Comments on current design M Church 11/13/03

drawing from http://www-btev.fnal.gov/DocDB/0002/000203/002/C0_collision_hall.pdf

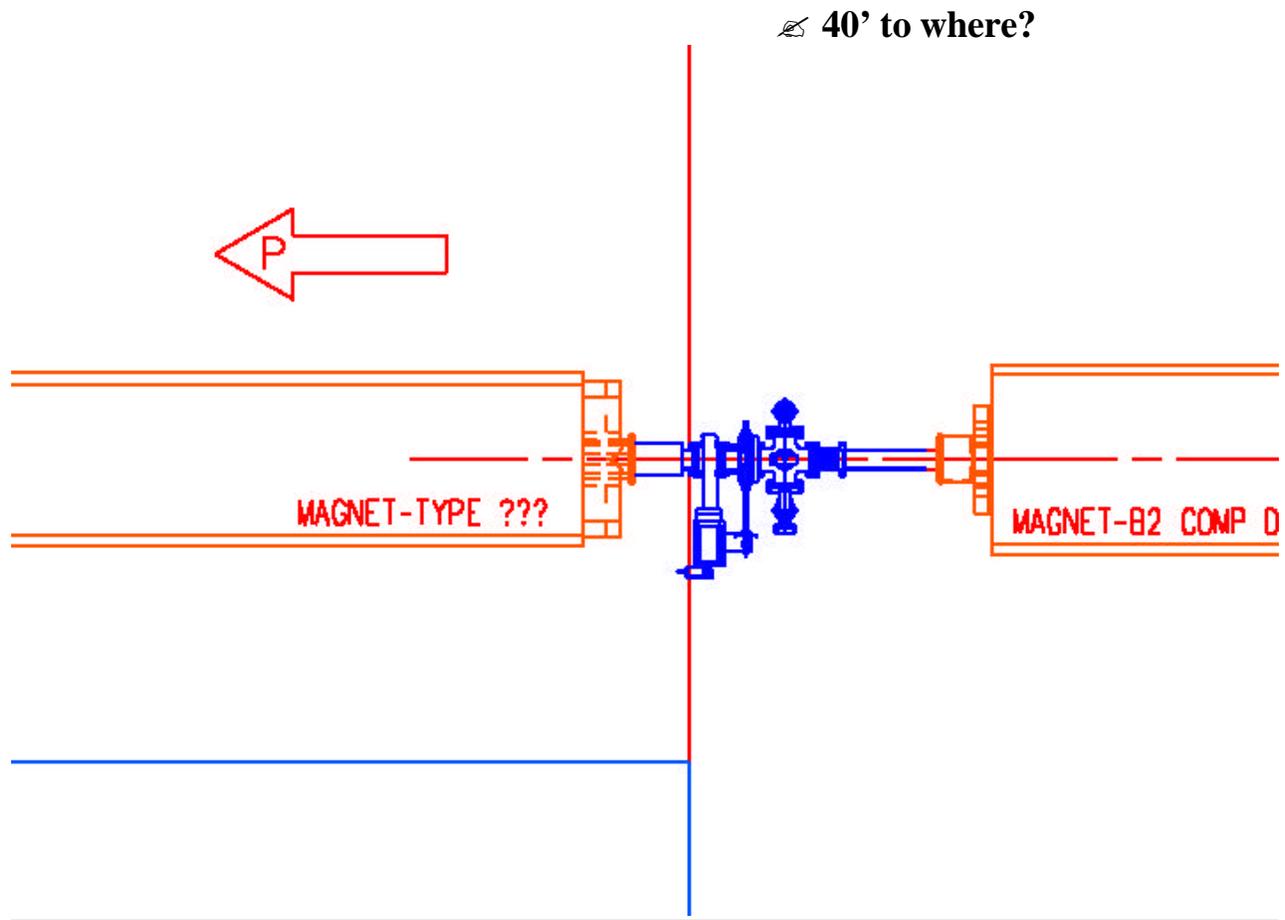
Location of Q1/Q2/Q3:

- 40' keep-clear distance from IR.... Measured to where?
